PLANNING COMMISSION

CITY OF NOVI

October 30, 2019 7:00 PM

MEMORANDUM

SHEET NAME
TRUCK TURNING PLAN

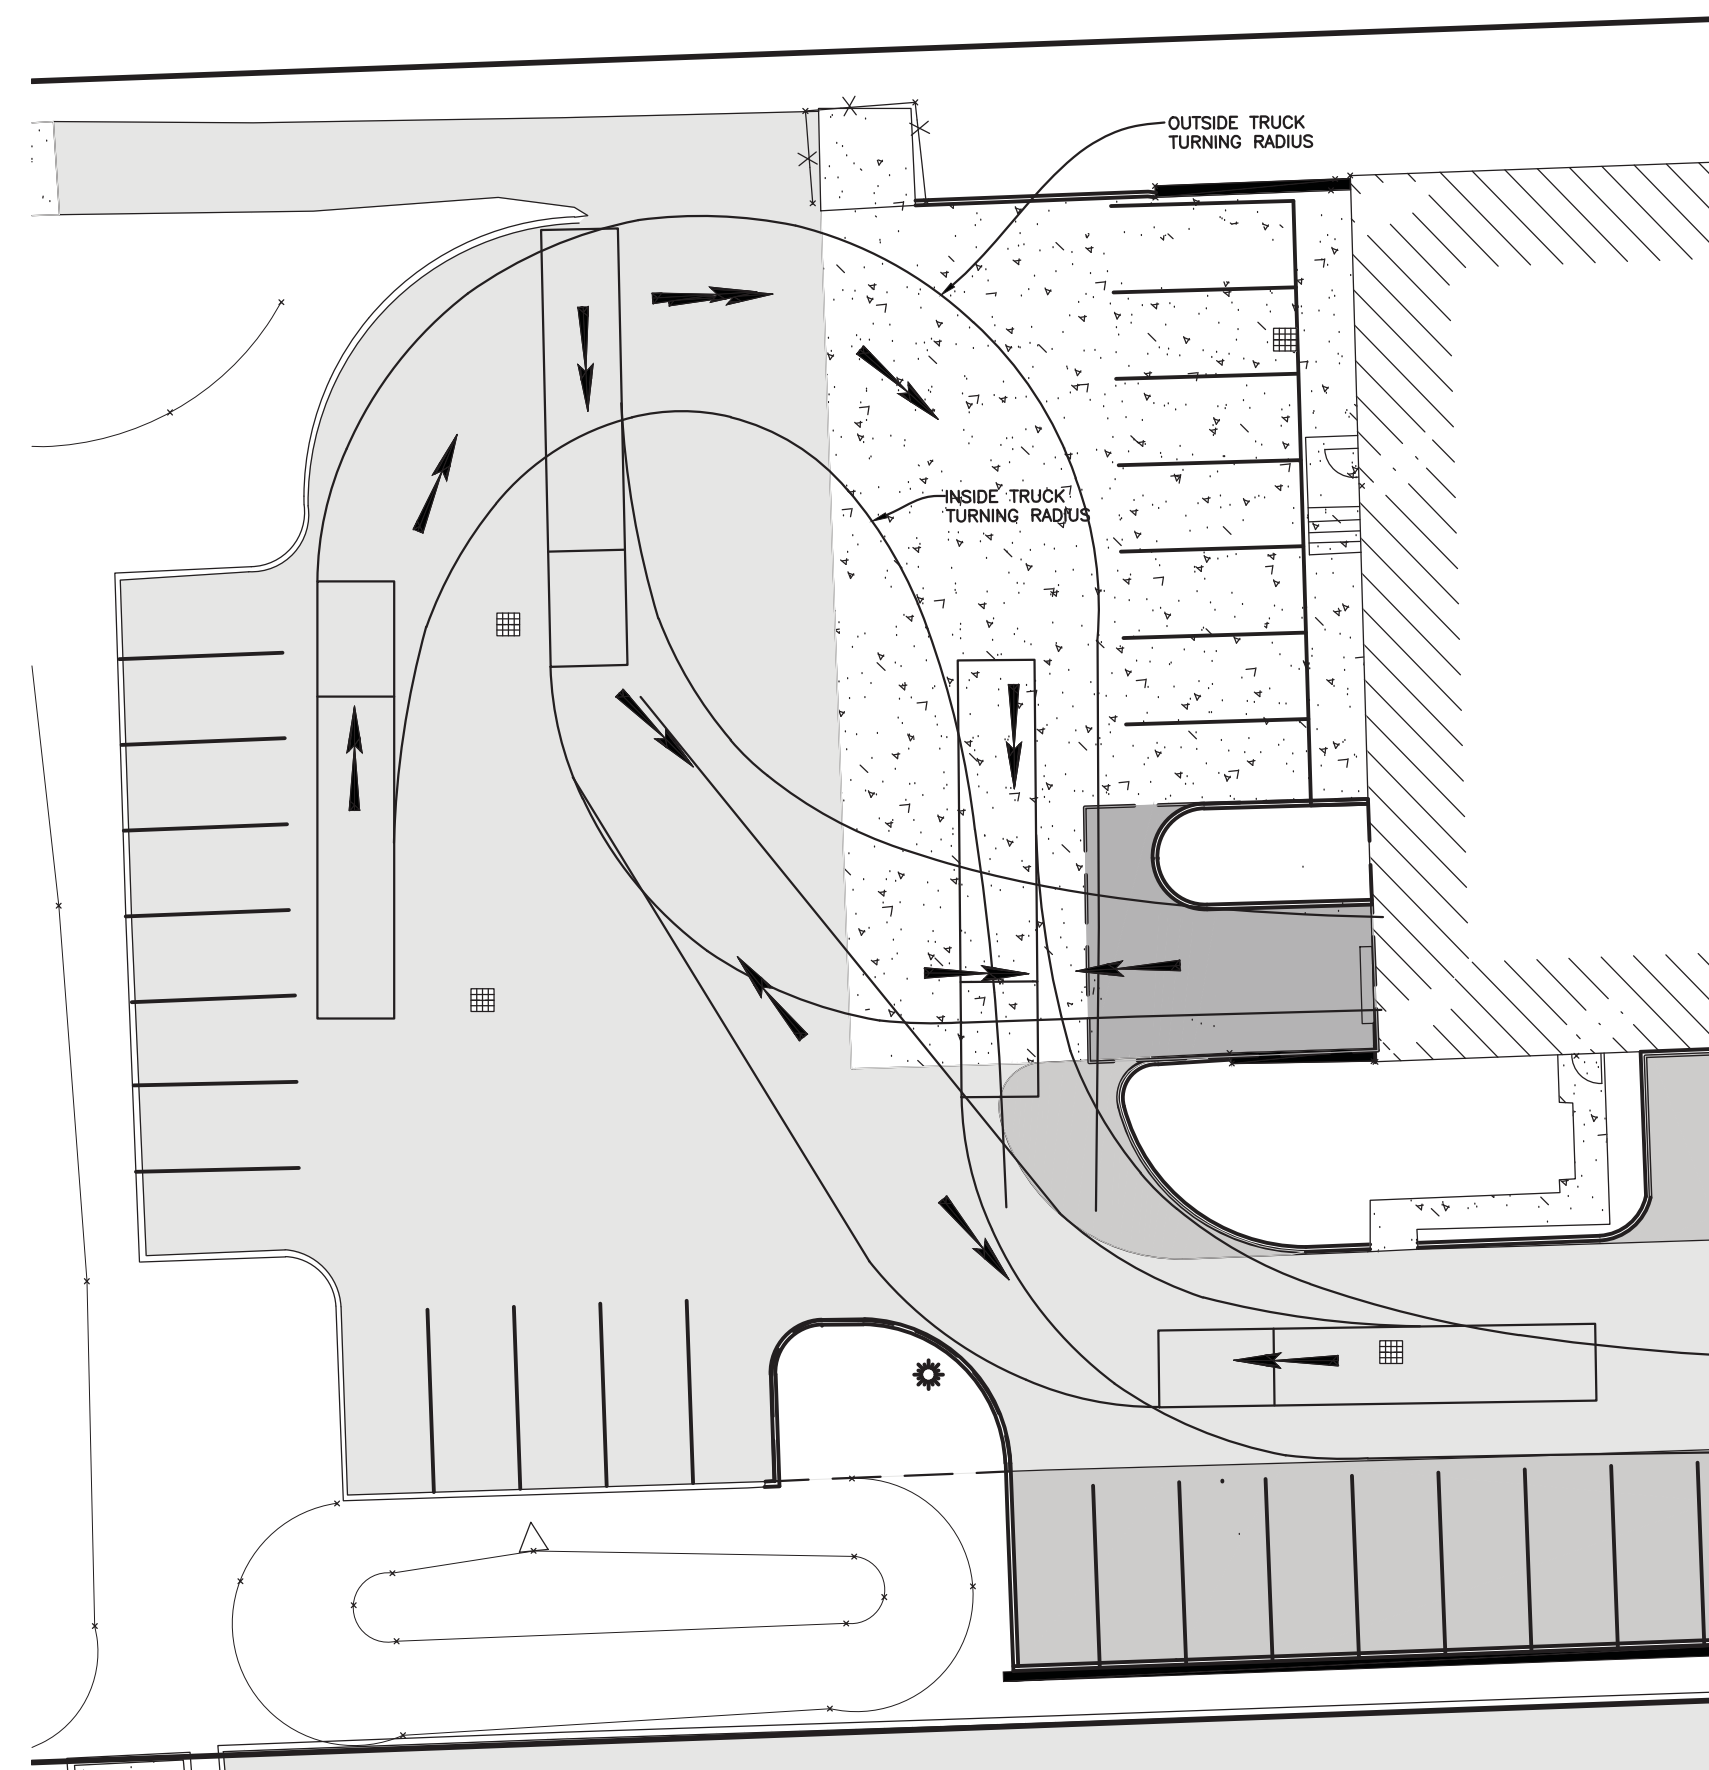
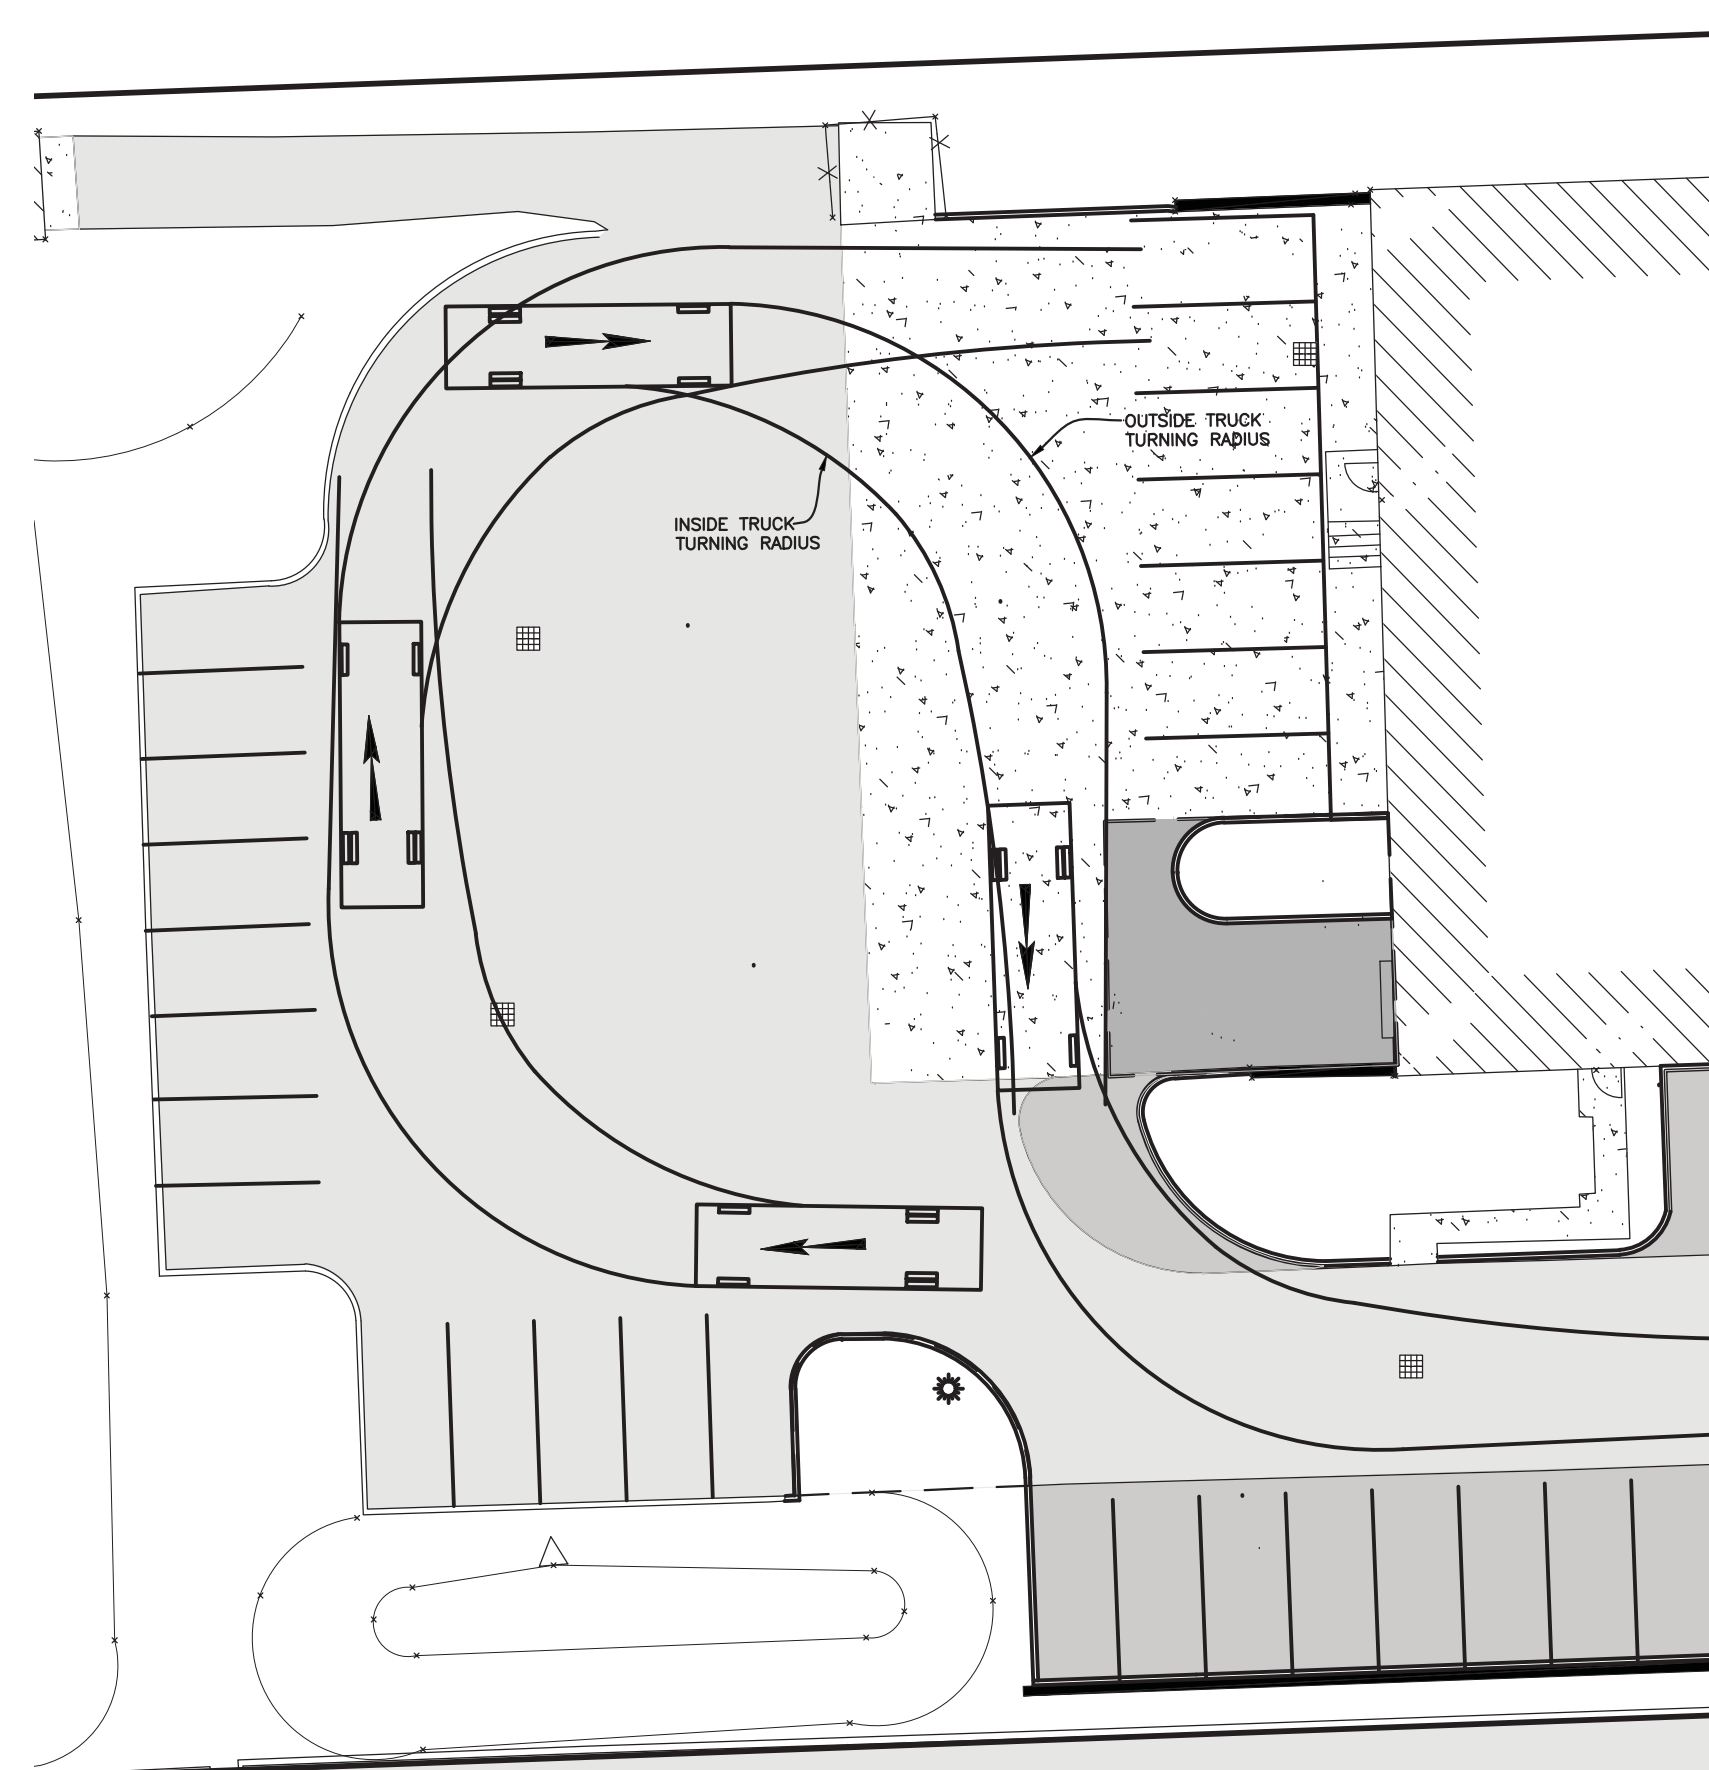
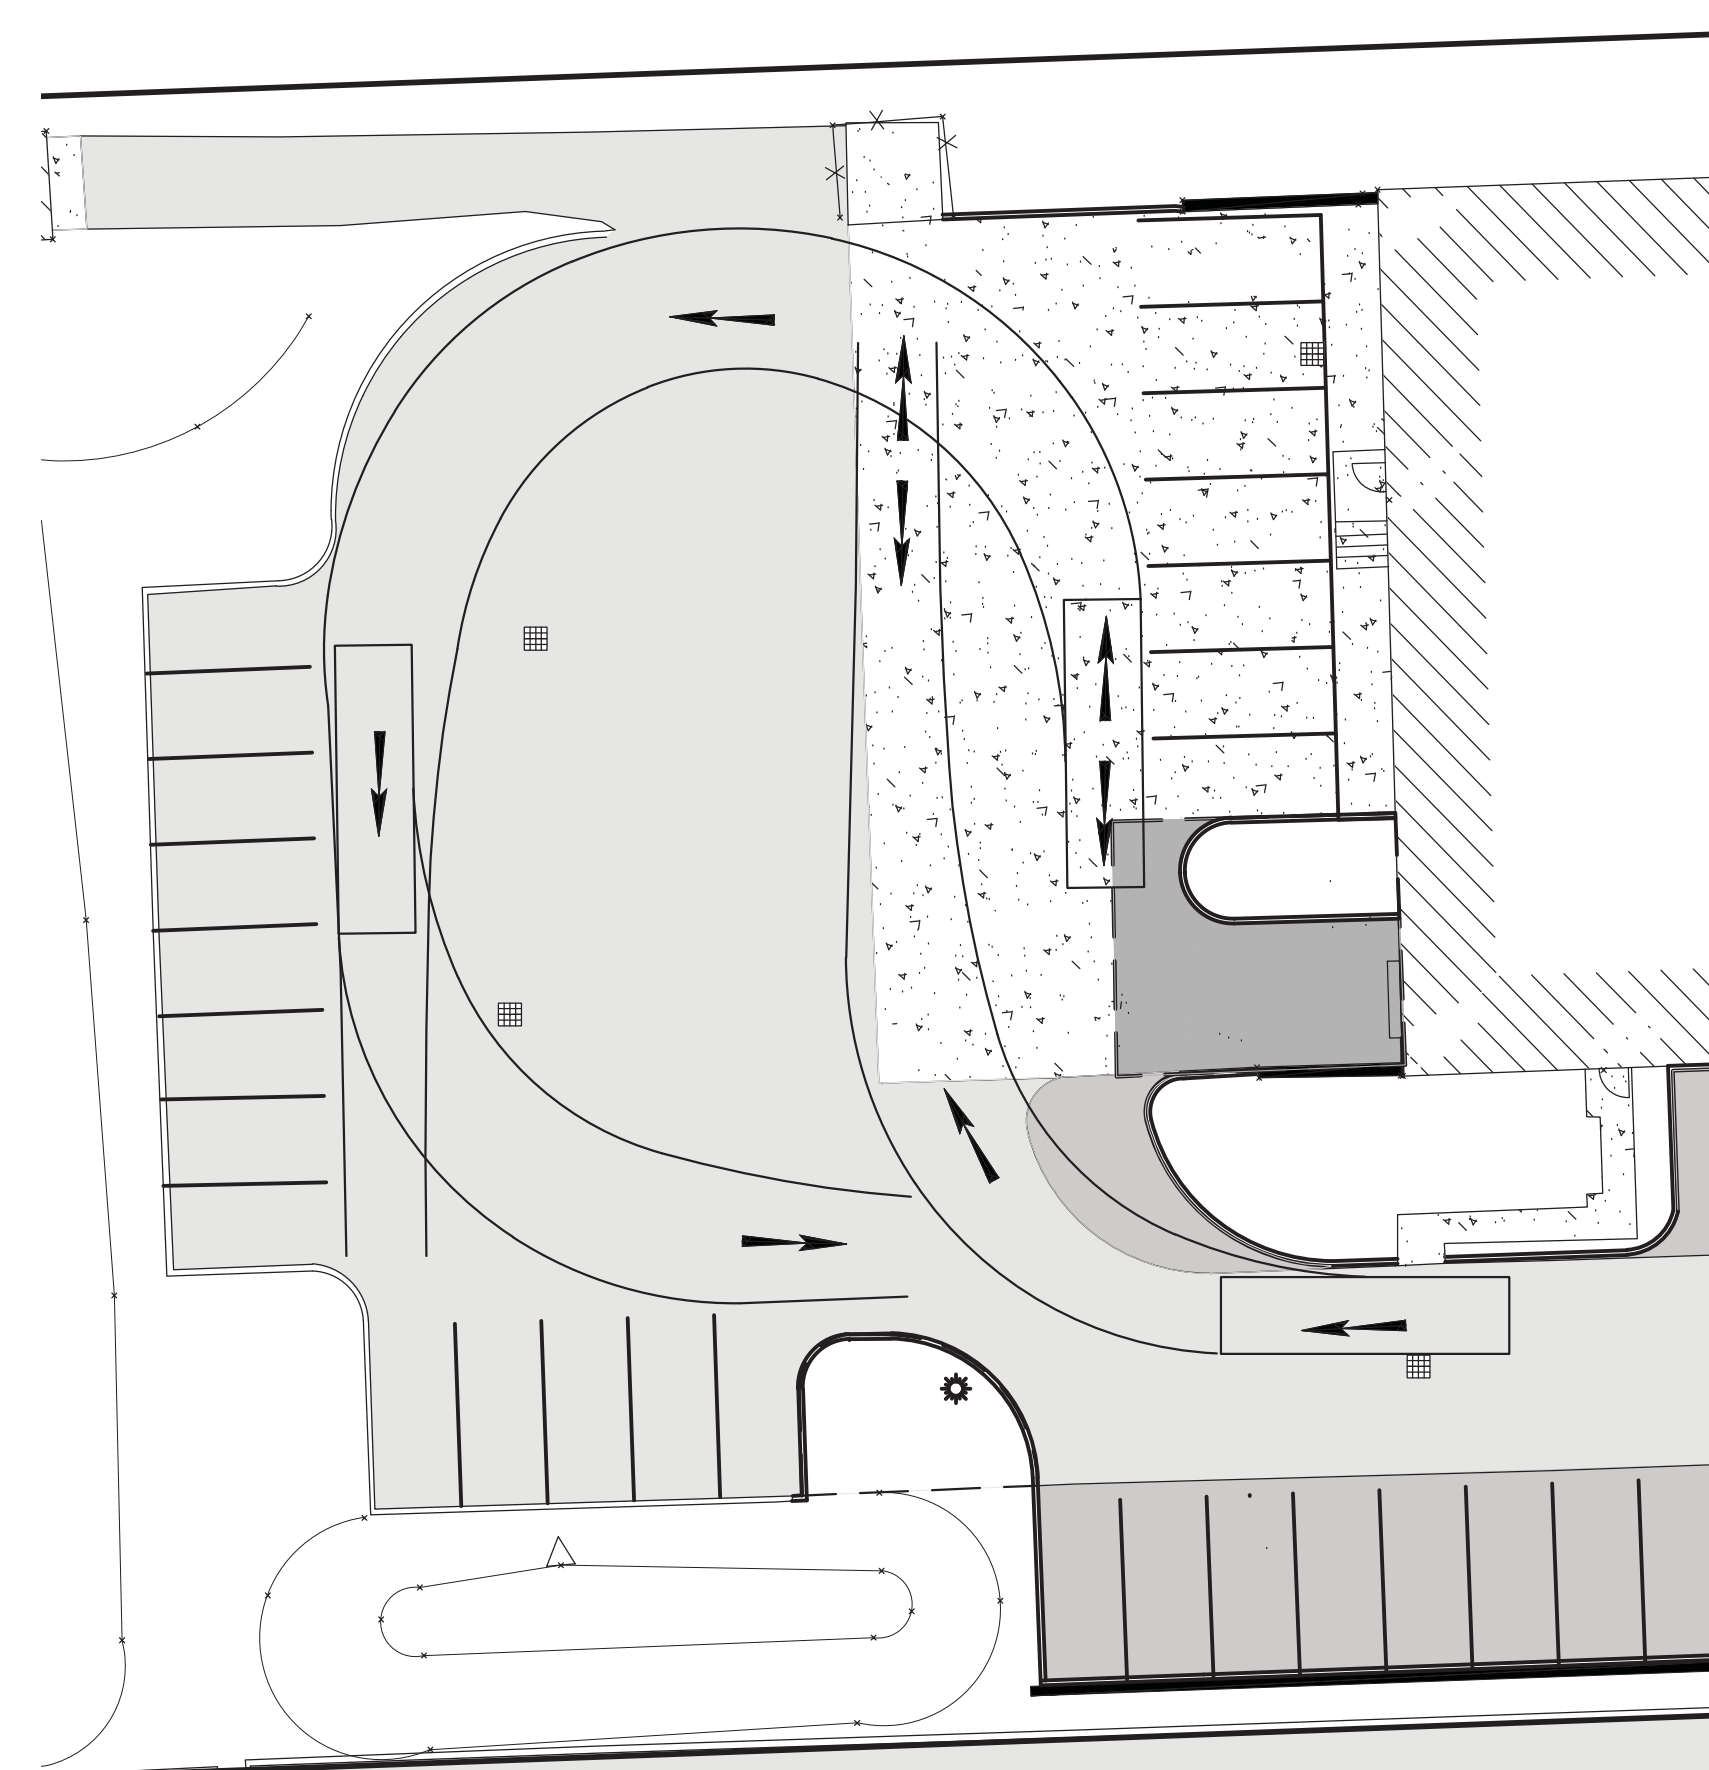
2. **The applicant shall provide a truck circulation diagram as noted in the Traffic review letter at the time of final site plan;**
3. Traffic waiver to allow Parking study in lieu of performing a Traffic Impact study because the change in number of trips from existing use is not significant, which is hereby granted;

A fire truck turning template, a dumpster/garbage truck turning template, and a WB-40 truck turning template are shown on sheet 5 of the revised plans.

A fire truck turning template, a dumpster/garbage truck turning template, and a WB-40 truck turning template are shown on sheet 5 of the revised plans.

Figure 1. City of Novi Regulated Wetland & Woodland Map (approximate parcel boundary shown in red). Regulated Woodland areas are shown in green and Regulated Wetland areas are shown in blue.

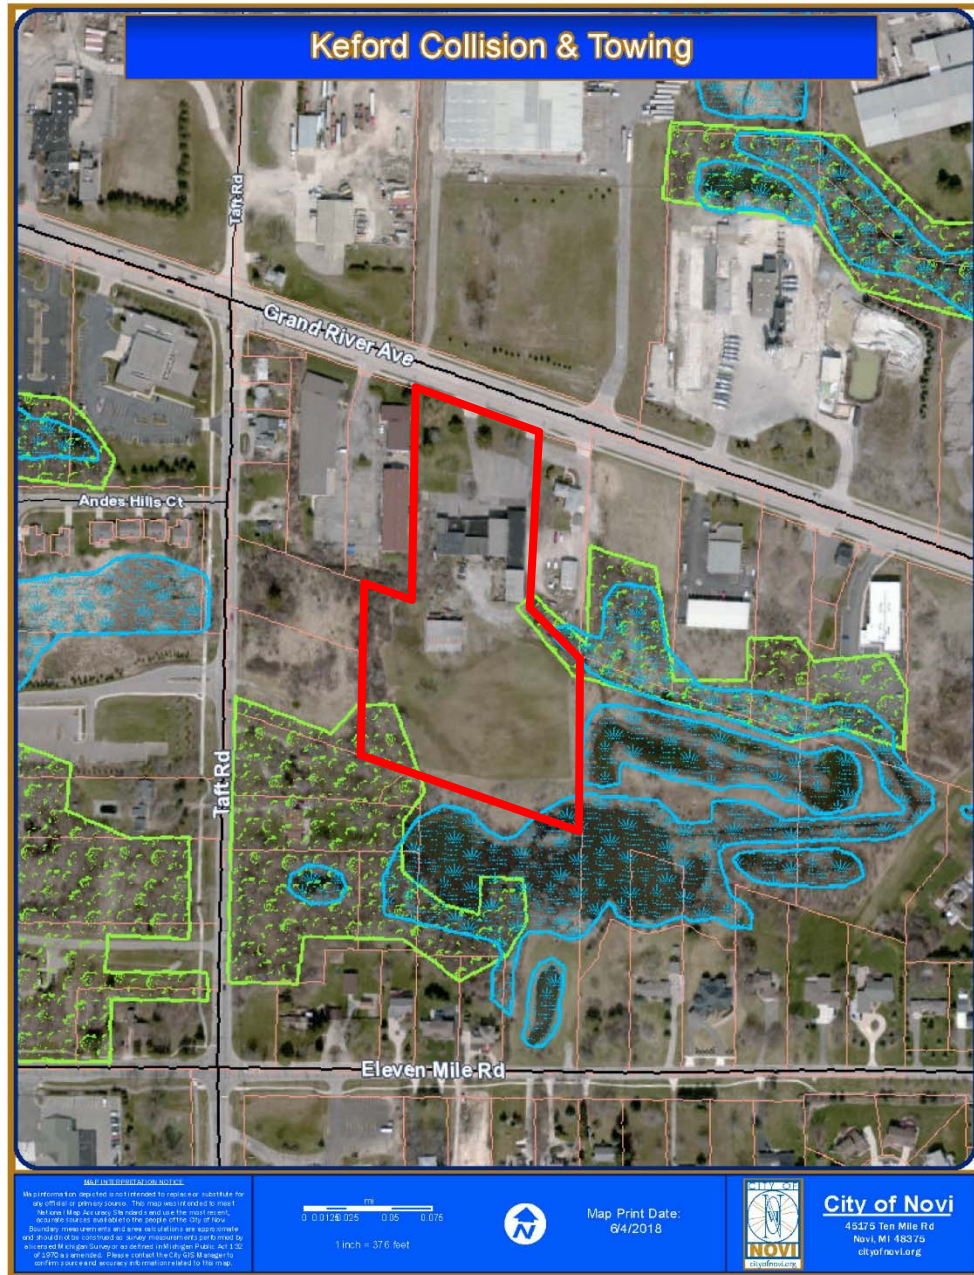
Environmental Consulting & Technology, Inc. (ECT) conducted a wetland evaluation for the proposed project site on July 25, 2018. ECT's in-office review of available materials included the City of Novi Regulated Wetland and Watercourse map (see Figure 1), USGS topographic quadrangle map, NRCS soils
